Re Application: 2015/3753/P Address: 36 Flask Walk, NW3 Date 20 August 2015

I would like to object to the above planning application for 36 Flask Walk on the following grounds.

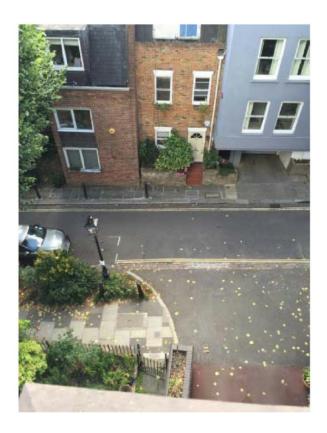
Photo 1: showing number 36 (center, beige door) in its cramped setting with the small but locally valued front area planting which will largely disappear. At the lower edge of the photo, the change in tarmac colour from black to red, marks the Lakis Close entrance drive which is private property, with no right of public access. A lorry parked outside number 36, as we have all experienced, blocks Flask Walk and Lakis Close, and also the four households who have rights to the underground parking under Number 34 located to the right, i.e. adjacent to the development at Number 36. (The garage entrance is under the grey building, number 34).
